Heli-Max™ **NOVUS**™ FP

Maintenance and Preflight Checks

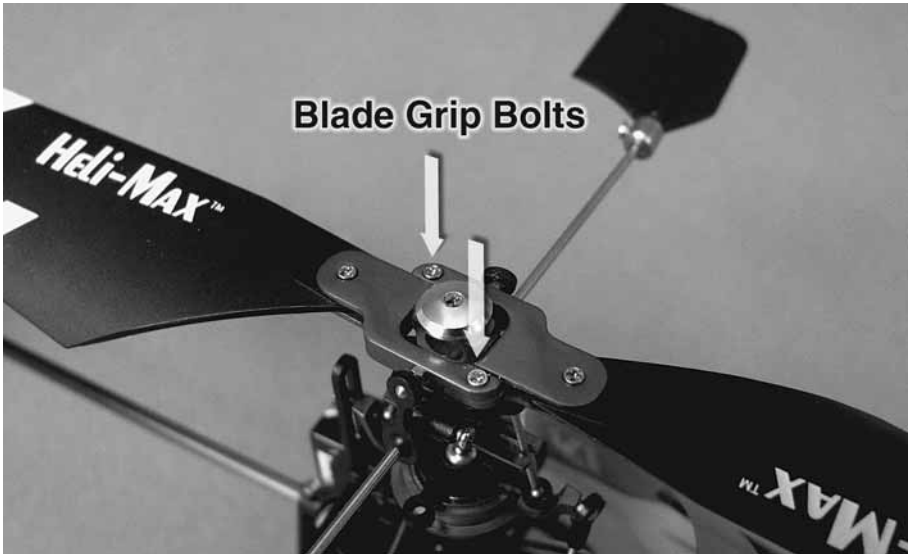
It has been found that the two bolts shown above may come loose during normal use. To prevent this from occurring the following steps must be performed. Remove one bolt and apply thread locker to the screw (GPMR6060 Great Planes Pro Threadlocker is recommended). Reinstall and tighten the screw. Repeat the steps for the other screw.
